## ADDENDUM

Lab Tech Bachelors Program  
Bakersfield College  
Kern Community College District  
550-0047

**Subject:** Addendum #2

**ACCESSIBLE FUME HOOD ELEVATION**

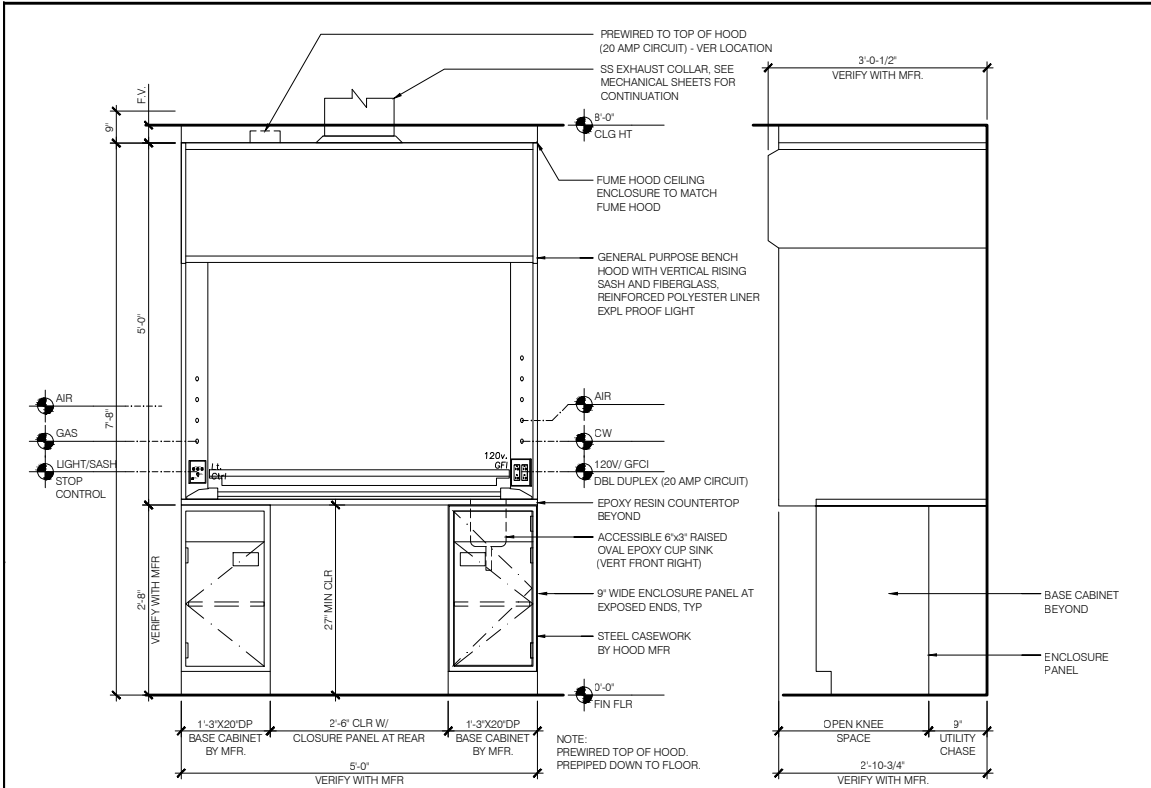
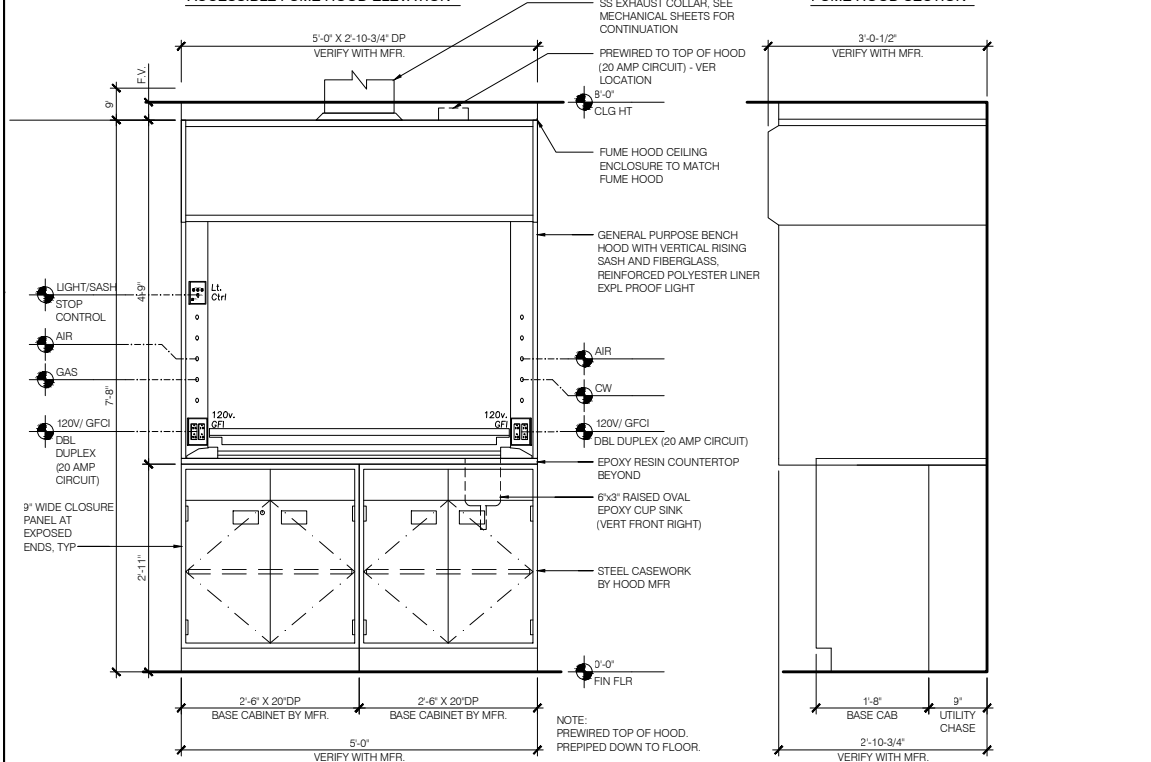
2.4.1 Replace Detail 33 on Sheet A8.20 with attached Detail 33. Fume hoods and supporting steel base cabinets to be provided by Owner and installed by Contractor as noted in Specification Section 011000. Fume hoods are pre-wired and pre-plumbed. See Mechanical, Electrical and Plumbing Sheets for additional information. Balance of steel cabinets with epoxy tops in Room 27A to be provided and installed by Contractor.
